SERVICE BULLETIN

M-1001

January 15, 1991

FLTC/FLHTC ULTRA UPDATE

Figure 1. Wiring Diagram Of Impedance Reducing Circuit Installed In Cruise Harness

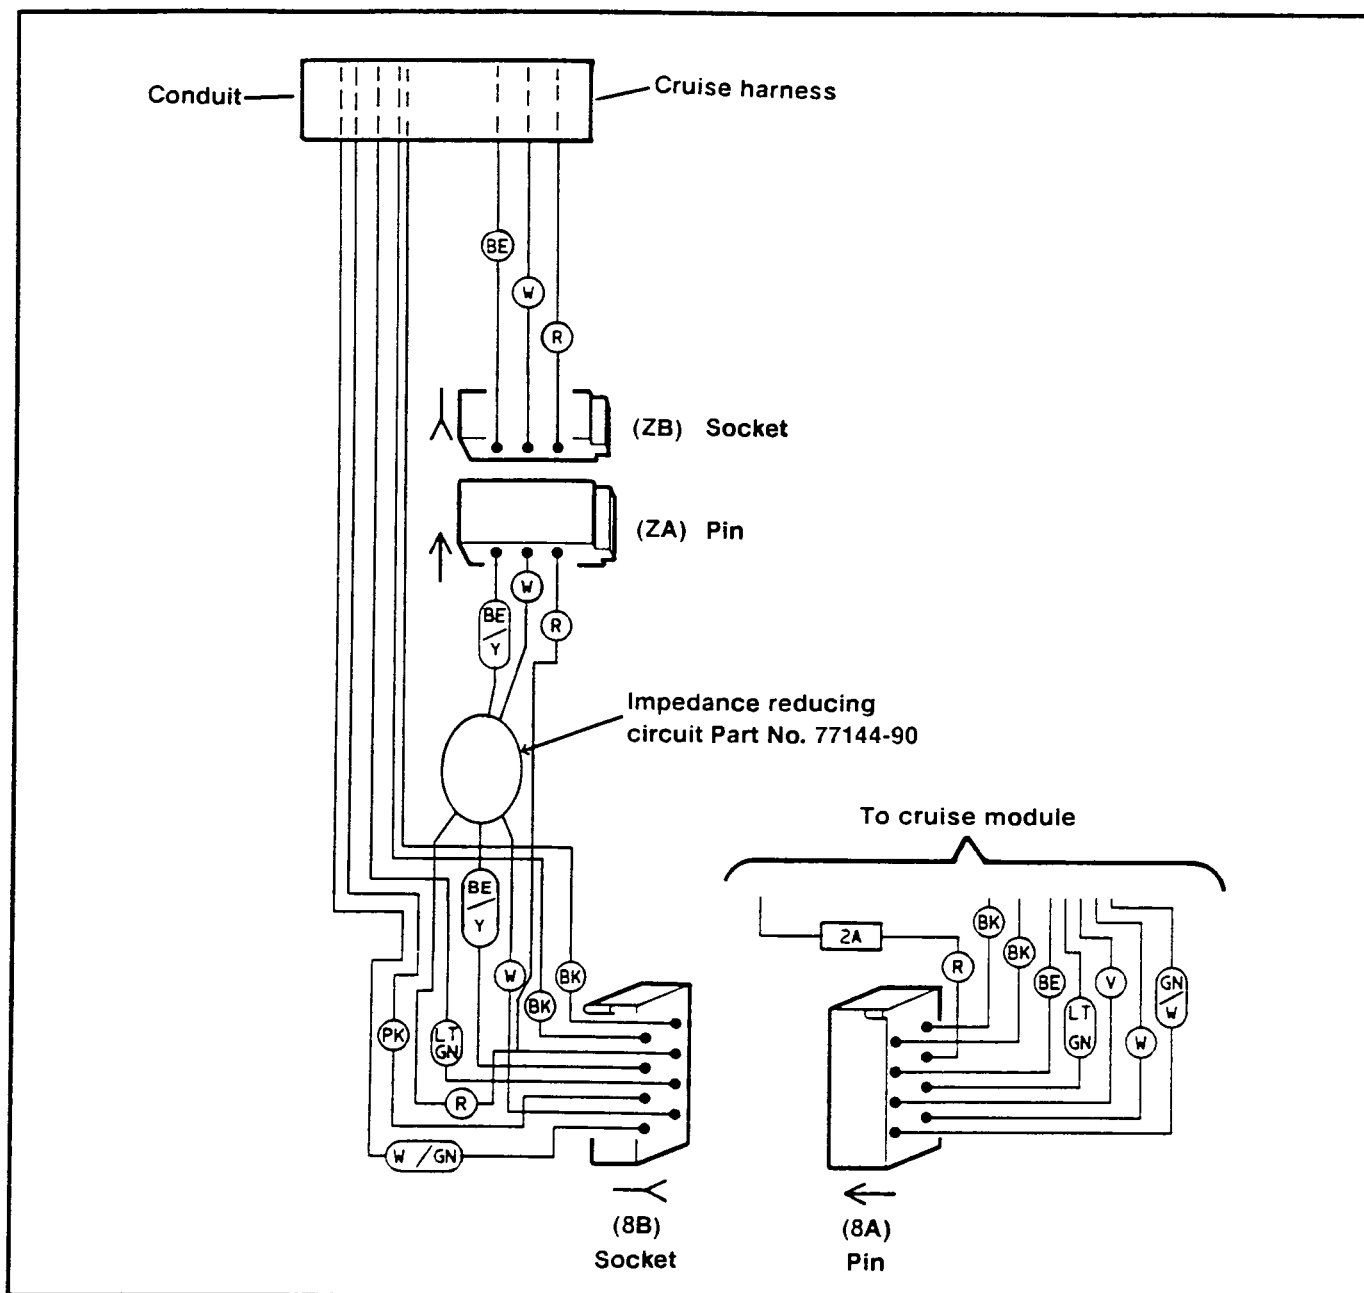
To replace Z-circuit remove the three pin terminals from connector ZA using PIN TERMINAL TOOL Part No. HD-97362-71 and remove the three socket terminals from connector 8B using Socket TERMINAL TOOL, Part No. HD-97364-71. Install new Z-circuit making certain terminals are connected as shown in Figure 1.

- A Z-circuit must be used with module Part No. 70958-90A
- Module Part No. 70958-90B does not require a Z-Circuit; but, system will function properly with a Z-Circuit. **Don't remove Z-Circuit if a 70958-90B module is being installed.**

Figure 2. Cutting Green/Black Wire On 1990 TLE-ULTRA Sidecar Sound System

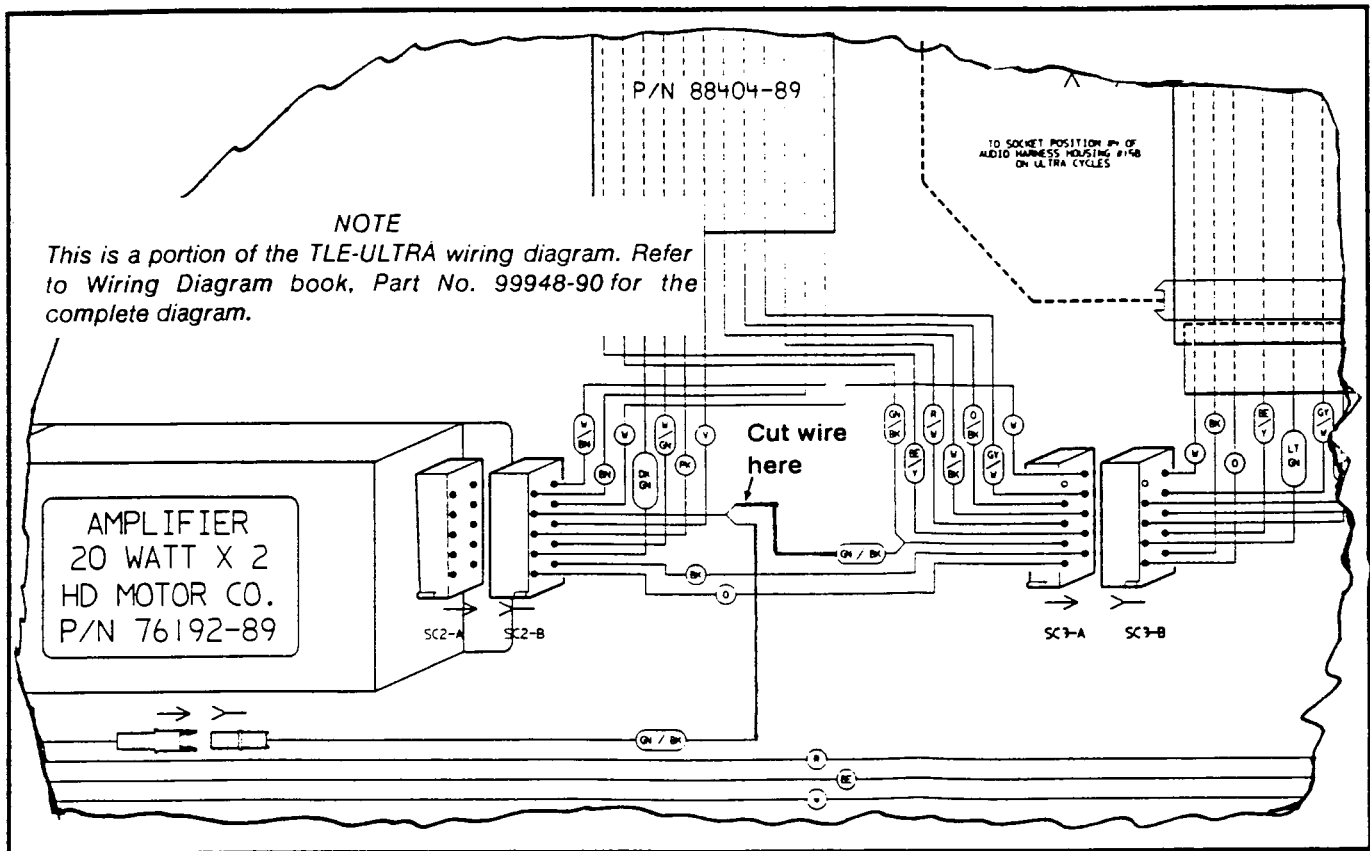
See Figure 2. To reduce alternator hum, locate green/black wire that connects between connectors SC2 and SC3. Cut this wire and cover the wire ends with electrical tape.

Figure 3. Throttle Cable Bracket Installation

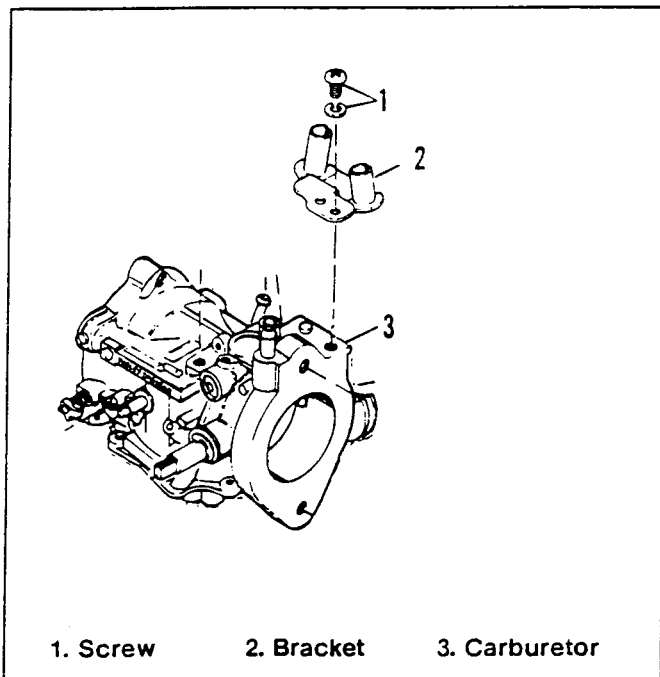
A replacement throttle cable bracket fabricated from thicker material will be available (approximately 2-15-91) in a kit, Part No. 27327-83A. The kit will contain the new bracket and a longer mounting screw. **This new bracket should be used on motorcycles equipped with cruise control.** See page 3 of this bulletin for installation instructions.

1. Refer to the CRUISE CONTROL- THROTTLE CABLES-1989 procedure in Section 8 of the 1984 To 1990 FLT/FXR SERVICE MANUAL, Part No. 99483-90. If necessary, loosen the throttle and idle cables and disconnect cables from the throttle wheel.
2. See Figure 3. Remove screw (1) and remove "old" bracket (2).
3. Connect cables to throttle wheel, install cable sheath ends in new bracket, mount new bracket on carburetor and secure with longer screw from kit.
4. Check cable adjustment following the CABLE ADJUSTMENT procedure contained in the Service Manual referenced in step 1 above.
